CHANGE TO THE PULLEYS OF A FEW TENSIONING ARMS FOR THE ACCESSORY UNIT DRIVE

TECHNICAL INFO NO. 1035

Image 1: Detailed view of pulley in its previous design (left) and new design (right)

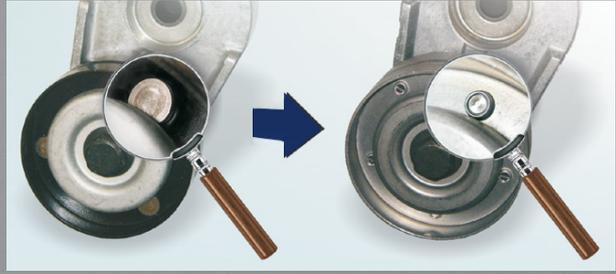
The differences are, as are shown in Image 1, the coating (previously black, now metal) and the connection between both race halves (previously riveted, now tox clinched).

During the transition period, we may have mixed stocks of both designs. Both versions meet the technical specifications and can be used without restrictions on the vehicles specified in the catalogue.
